[Docket No. FAA-2007-0096; Directorate Identifier 2007-NE-39-AD; Amendment 39-16141; AD 2009-26-06]

Airworthiness Directives; Honeywell International Inc. ALF502 Series and LF507 Series Turbofan Engines

ACTION: Final rule.

Figure 1 - Fuel Manifold Assembly-to-Fire Shield Interface Area

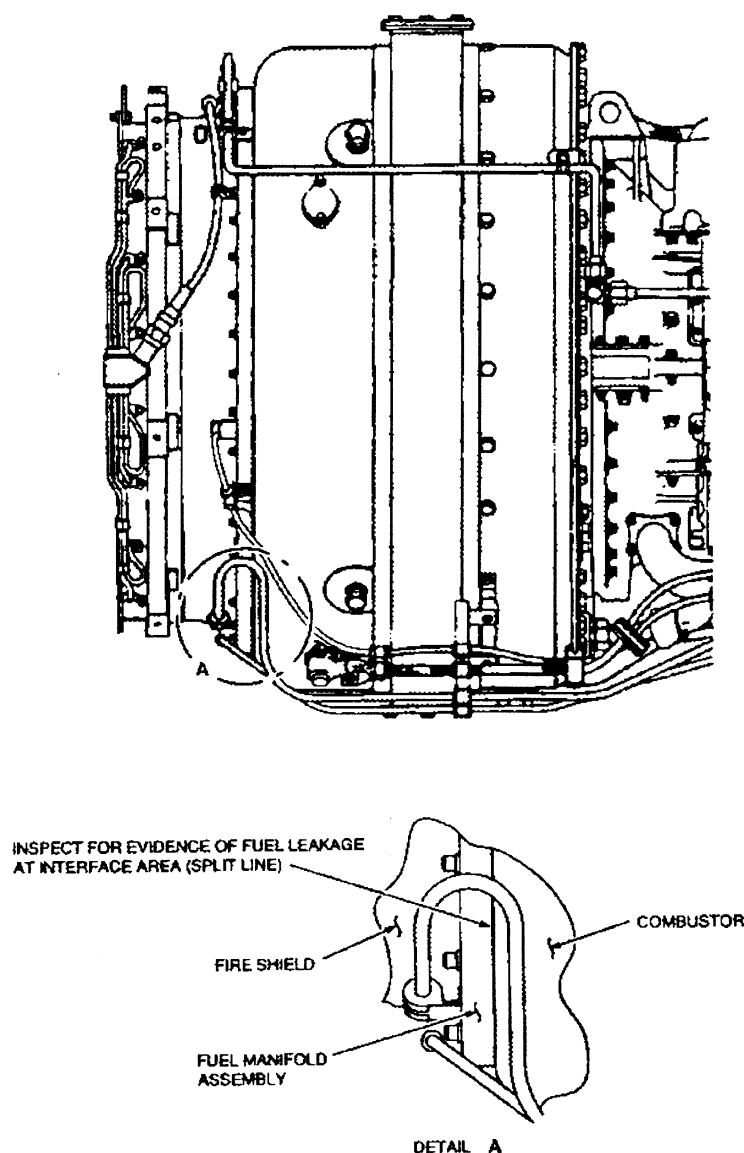
(g) For fuel manifold assemblies, P/Ns 2–163–620–37 or 2–163–620–38, with 1,800 or more CSN or cycles-since-overhaul (CSO), inspect for leaks within 300 CIS after the effective date of this AD as follows:

(2) With the engine operating, look for fuel leaking from the fuel manifold assembly to the fire shield interface area (see Figure 1 of this AD). No leaks allowed.

(5) Look for fuel leaking from the fuel manifold assembly to the fire shield interface area (see Figure 1 of this AD). No leaks allowed.

(3) If you find any leaks, shutdown the engine and replace the fuel manifold assembly with an FAA-approved serviceable assembly.

(6) If you find any leaks, replace the fuel manifold assembly with an FAA-approved serviceable assembly.
